Reclamation Plan Technical Revision No. 6
(Clarification and Response to Comments)

Front Range Aggregates Parkdale Quarry
Freemont County, Colorado

Colorado Division of Reclamation, Mining, and Safety Permit #M-1997-054

**Reclamation Plan Technical Revision
Front Range Aggregates Parkdale Quarry
Freemont County, Colorado
Colorado Division of Reclamation, Mining, and Safety Permit #M-1997-054**

Reclamation Slope Design Schematic

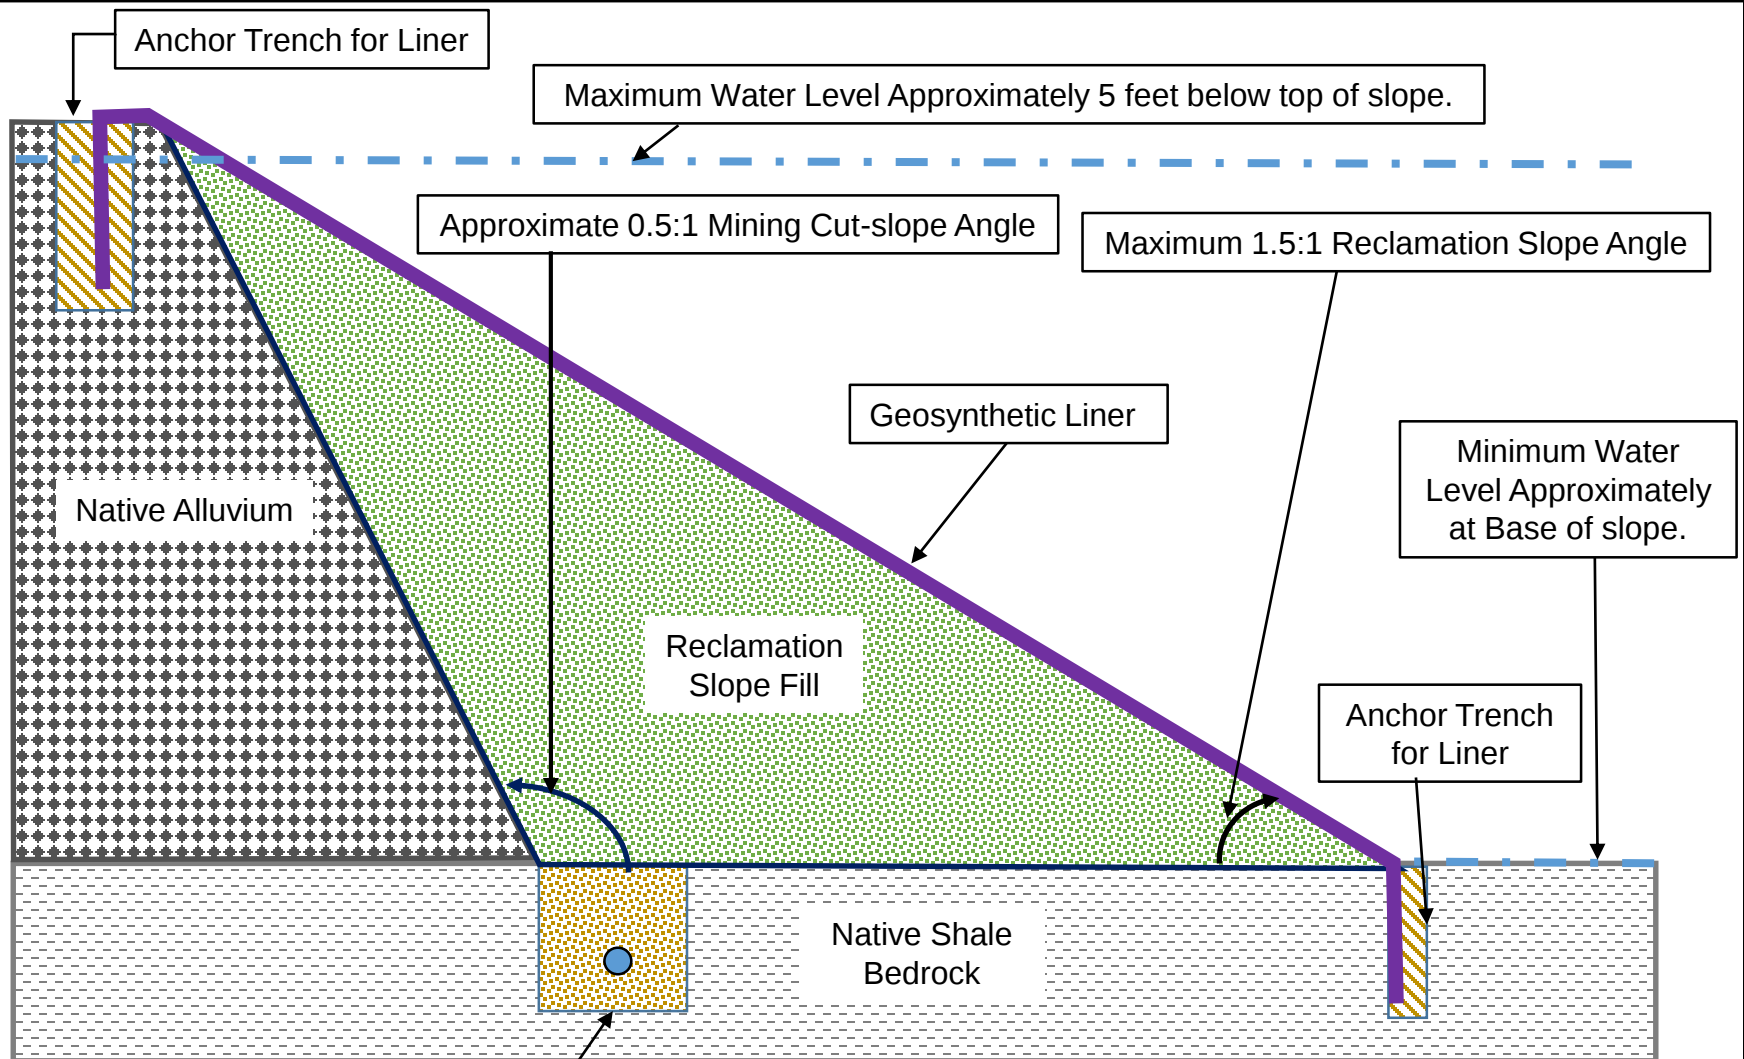
Cover Letter, Last Paragraph: The closing paragraph proposes “Increasing the slope angle from 3:1 (horizontal to vertical) to 2:1 (horizontal to vertical)”. Rule 3.1.5(7) of the Mineral Rules and Regulations of The Colorado Mined Land Reclamation Board for The Extraction of Construction Materials requires “*In all cases where a lake or pond is produced as a portion of the Reclamation Plan, all slopes, unless otherwise approved by the Board or Office, shall be no steeper than a ratio of 2:1 (horizontal to vertical ratio), except from 5 feet above to 10 feet below the expected water line where slopes shall be not steeper than 3:1.*” Please provide the following:

- a. The expected operating level of the water storage facility,
- b. Engineering drawings, sections, and/or details showing the expected water line/operating level and the 3H:1V side slopes where required by Rule 3.1.5(7).

Pits August 1999. The attached Reclamation Slope Design Schematic shows the expected operating levels of the water storage facility and the relationship of the operating levels to the reservoir side slopes.

The design capacity of the drain system assumes 95,000 square feet of wall below the maximum observed high ground water (9,500 linear feet of wall with average water depth of 10 feet), and an average hydraulic conductivity of 1.0 foot per day, which yields 2.18 acre-feet of water per day.

Drainage pipe is 10-inch diameter, schedule 40 polyvinyl chloride with 0.10 slots on an approximate slot spacing of 0.50 inches, and with a total length of approximately 9,500 feet, draining to a central sump on the southeast edge of the mined area. The total passive flow capacity of the drainage pipe = approximately 2.5 acre-feet per day (580 gallons per minute, or 1.29 cubic feet per second).

Groundwater Drain Schematic Design Detail

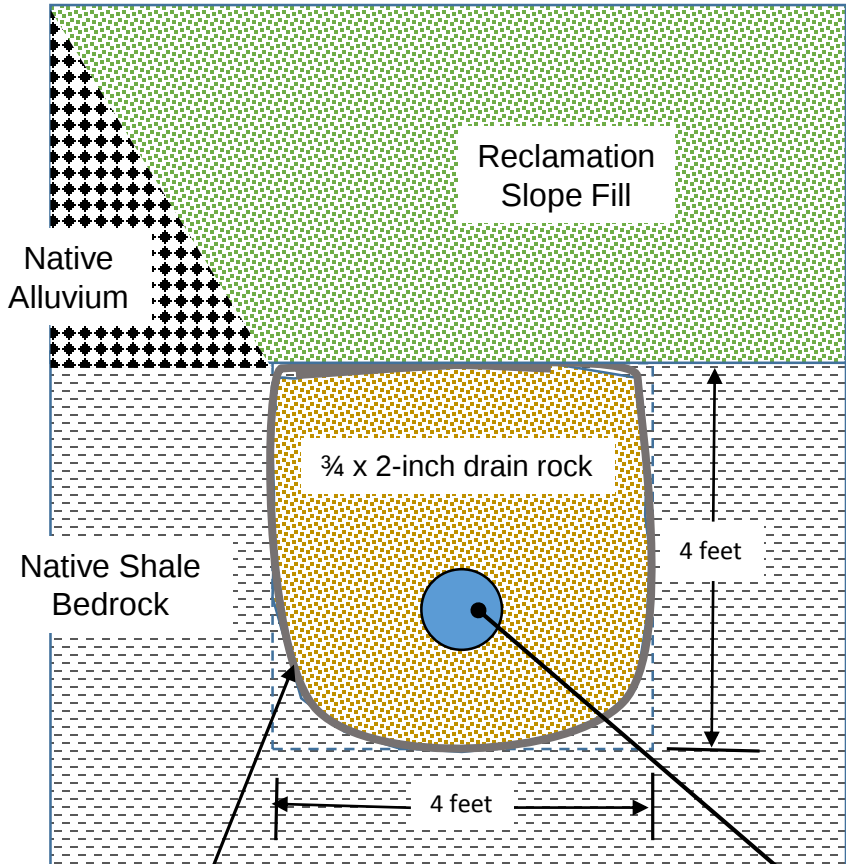
Applegate Group Memorandum – The opening paragraph mentions: a) the “proposed groundwater drain”. The Division could not find any information on the groundwater drain; b) “Soil Strength parameters were determined from tests performed by North American Testing, Inc.”, yet the attached lab report is from Geo-Logic Associates, and assumption No. 3 states “Soil Parameters for the undisturbed alluvium and bedrock were based on our previous analysis”; and c) “The section geometry was based off a figure provided by you (*David Bieber*)”. Please provide the following:

- a. Drawings and analyses related to the groundwater drain in order for the Division to understand the intent and evaluate its effectiveness,
- b. Clarification on the source(s) for each soil parameter (“Slope Fill”, “Native Alluvium”, and “Native Shale Bedrock”) used in the stability analyses, and
- c. The section geometry based off a figure provided by David Bieber. This should include the final mined slope of the alluvium and the proposed liner for comparison to the slope stability analyses. (*Note: based on Comment No. 1 above, this section geometry should be revised.*)

The proposed groundwater drain referenced in the Applegate Group Memorandum is shown on the attached Reclamation Slope Design Schematic and Groundwater Drain Schematic Design Detail.

The attached Groundwater Drain Schematic Design Detail includes the analysis used for design of the groundwater drain is attached.

The 4-foot by 4-foot, gravel filled groundwater drain system with 10-inch drain pipe, filter fabric wrapping, draining by gravity to a central sump at the east end of the pit.

Date: September 30, 2015
To: David Bieber, PG
From: Craig Ullmann, PE
Subject: **Parkdale Slope Stability**

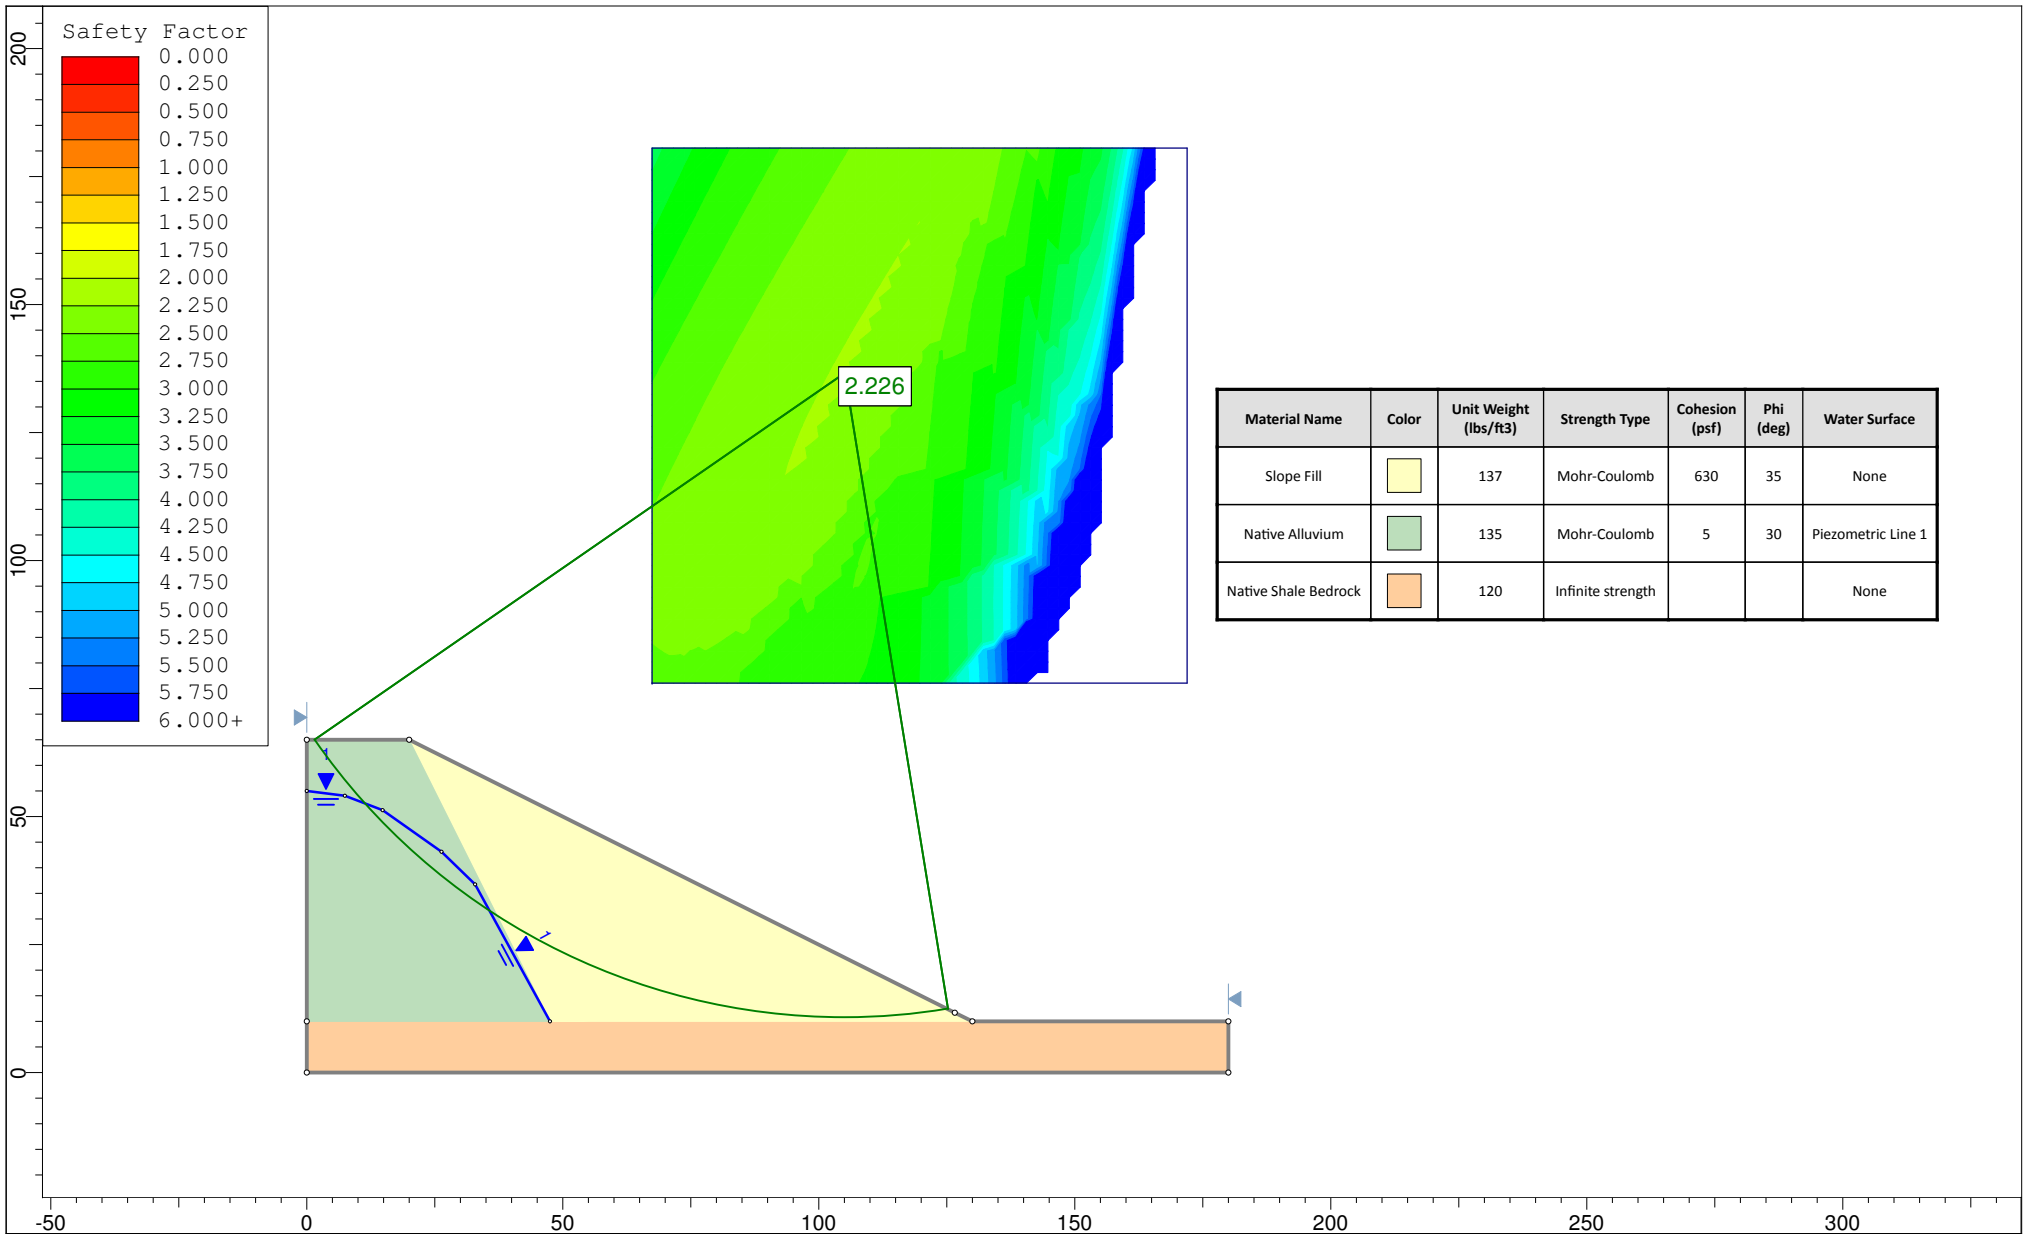
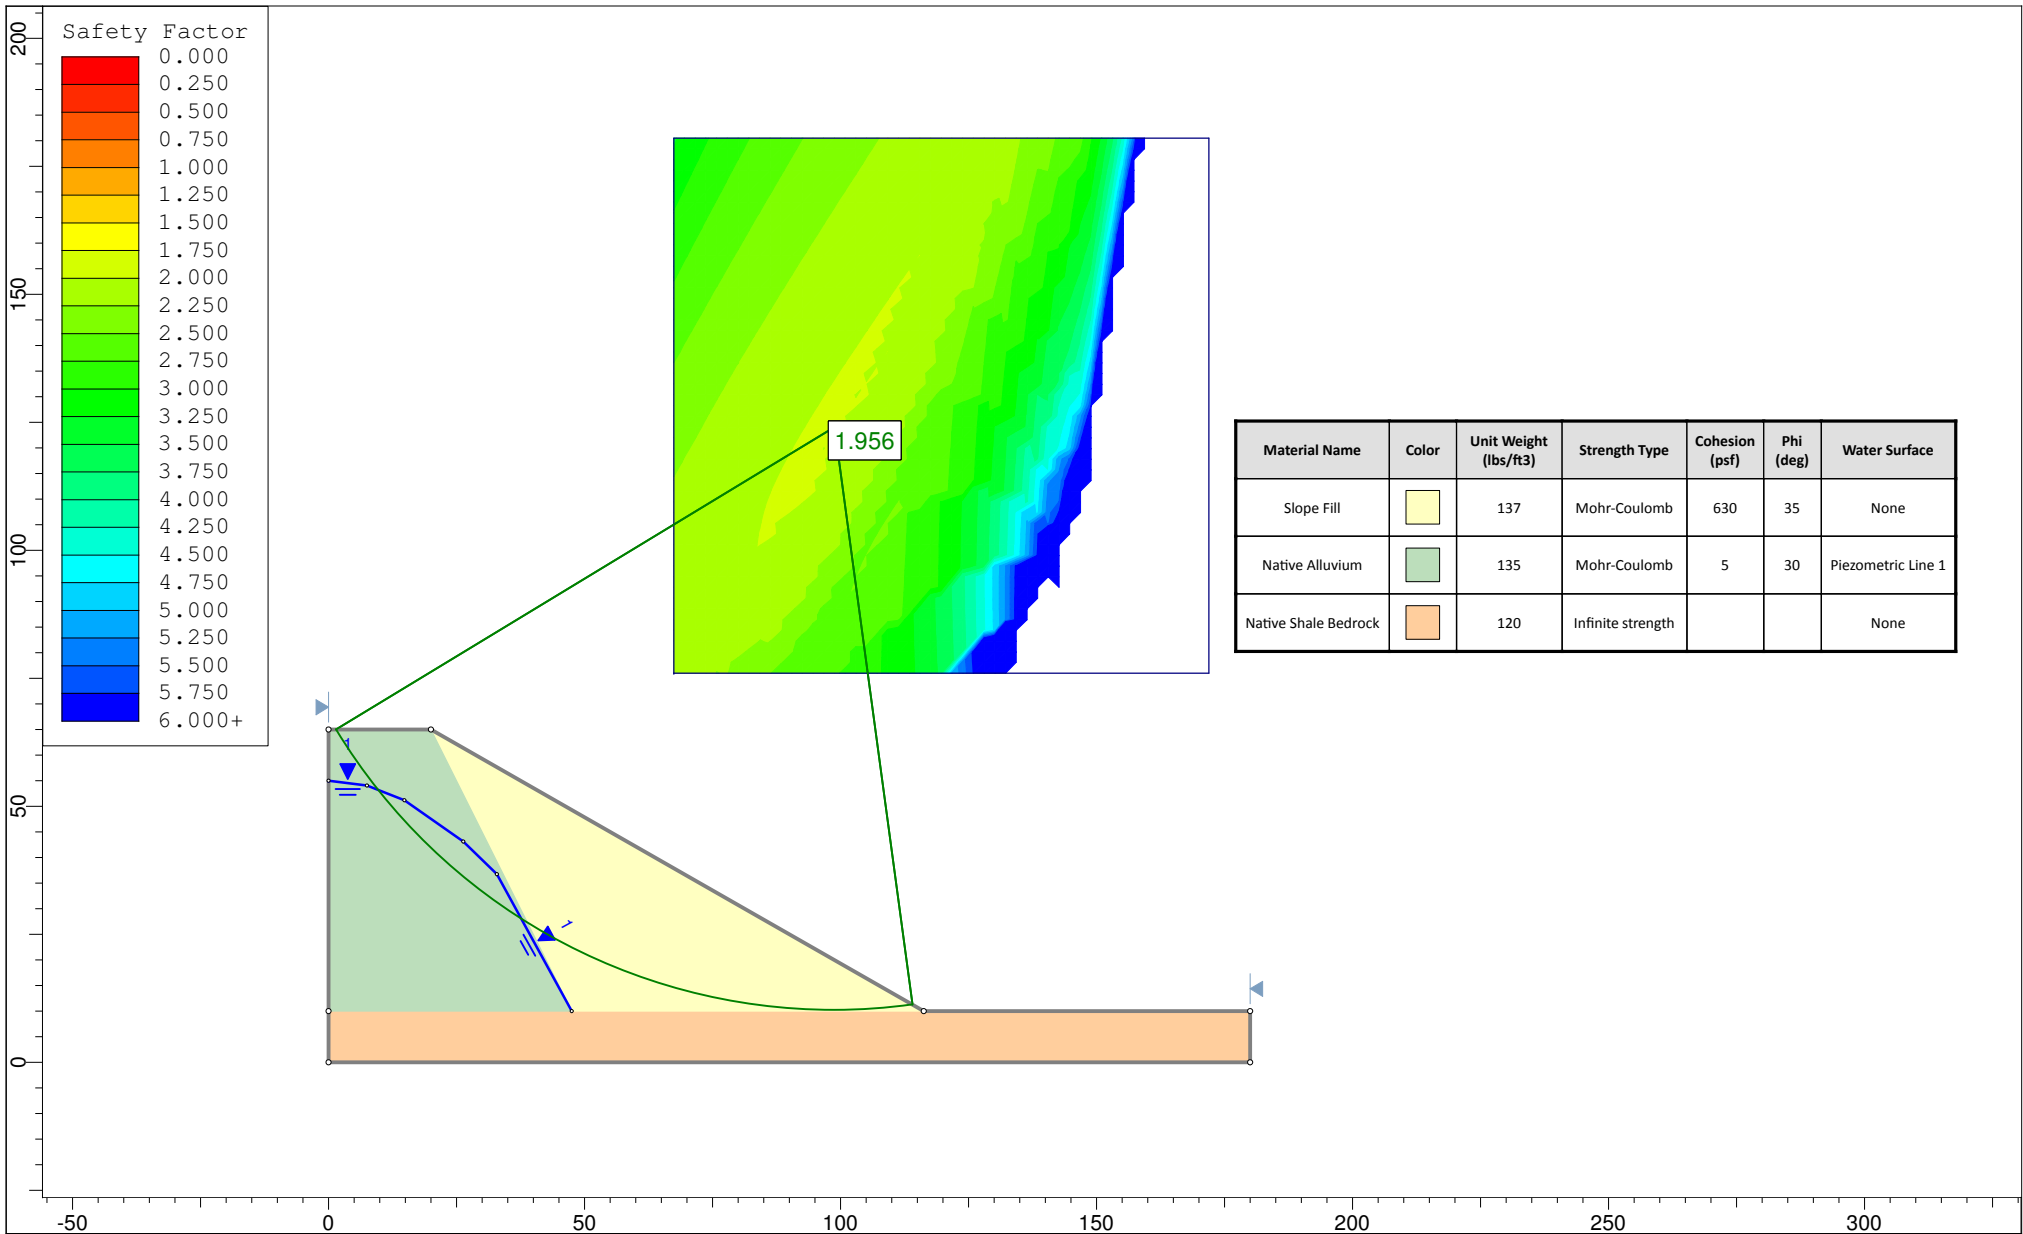
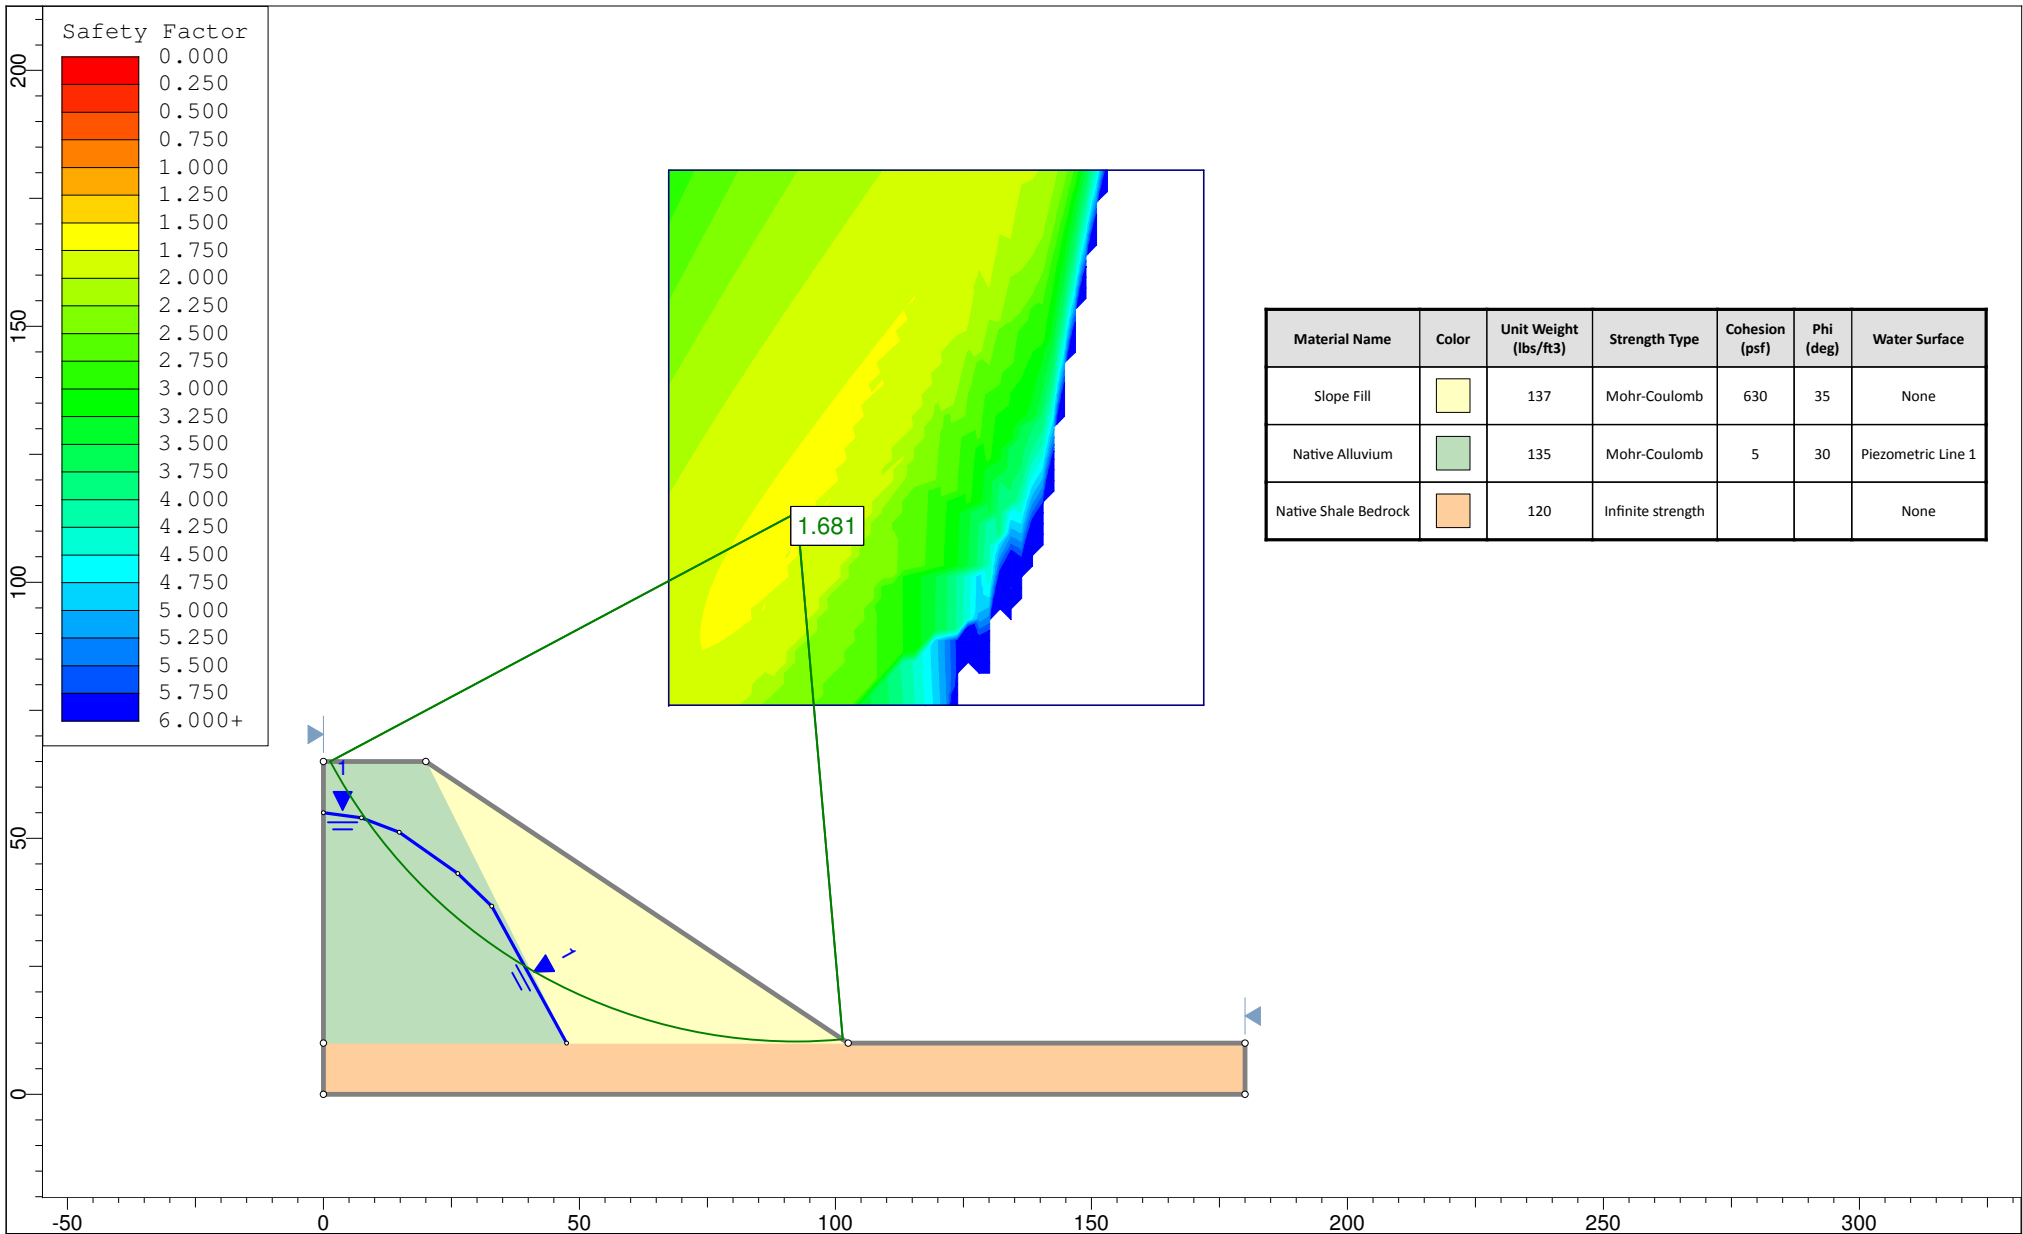
Slope Stability Analyses: Based on the aforementioned Rule 3.1.5(7), the stability analyses should be re-run with the appropriate slope geometry. Please provide the updated analyses.

It should not be necessary to rerun the stability analysis for slopes flatter than 2:1, as the analysis was run for slopes of 2:1, 1.75:1, and 1.5:1; all of which were demonstrated to have FOS values exceeding the minimum FOS of 1.5 for dam embankments specified in the Colorado Office of the State Engineer's *Rules and Regulations for Dam Safety and Dam Construction*. By the nature of the calculations used to perform FOS analysis, slopes flatter than those modeled will also have FOS values exceeding 1.5.

The model was originally performed at a slope of 2:1 and subsequent models were performed at slopes of 1.75:1 and 1.5:1.
